## IEEE P802.15 Wireless Personal Area Networks

Project	IEEE P802.15 Working Group for Wireless Personal Area Networks (WPANs)	
Title	<b>D00 running comment resolution</b>	
Date Submitted	[3 May, 2005]	
Source	[James P. K. Gilb] [Appairant Technologies] [16990 Via Tazon, #125, San Diego, CA 92127]	Voice: [858-485-6401] Fax: [858-485-6406] E-mail: [last name at ieee dot org]
Re:	[]	
Abstract	[This document is a record of comment resolutions for draft D00 of 802.15.3b.]	
Purpose	[To provide a record of the comment resolutions for draft D00 of 802.15.3b.]	
Notice	This document has been prepared to assist the IEEE P802.15. It is offered as a basis for discussion and is not binding on the contributing individual(s) or organization(s). The material in this document is subject to change in form and content after further study. The contributor(s) reserve(s) the right to add, amend or withdraw material contained herein.	
Release	The contributor acknowledges and accepts that this contribution becomes the property of IEEE and may be made publicly available by P802.15.

# 1. Comment resolution in Atlanta

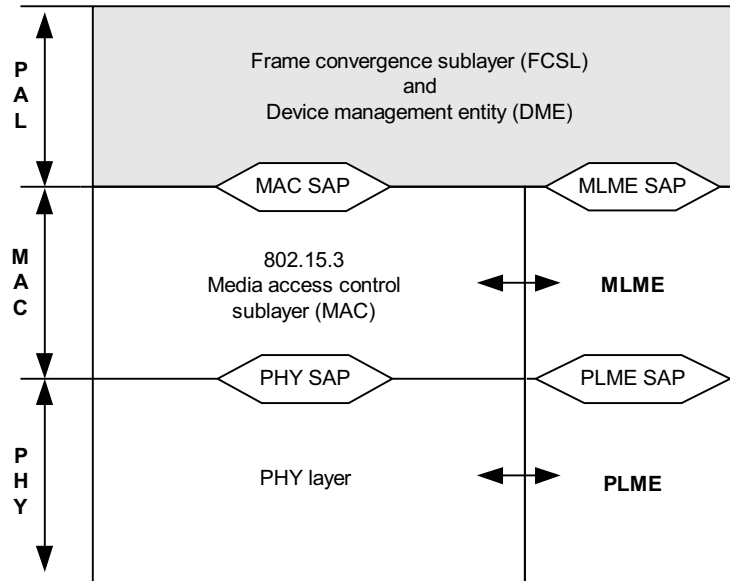
CID 154: ACCEPT IN PRINCIPLE. Replace the current model with the picture in 15-05-0151-04.

CID 29: ACCEPT IN PRINCIPLE. Replace the current model with the picture in 15-05-0151-04. Also, editorial text will be added to explain the changes and the reasons for them changes.

CID 330: ACCEPT IN PRINCIPLE. Replace the current model with the picture in 15-05-0151-04.
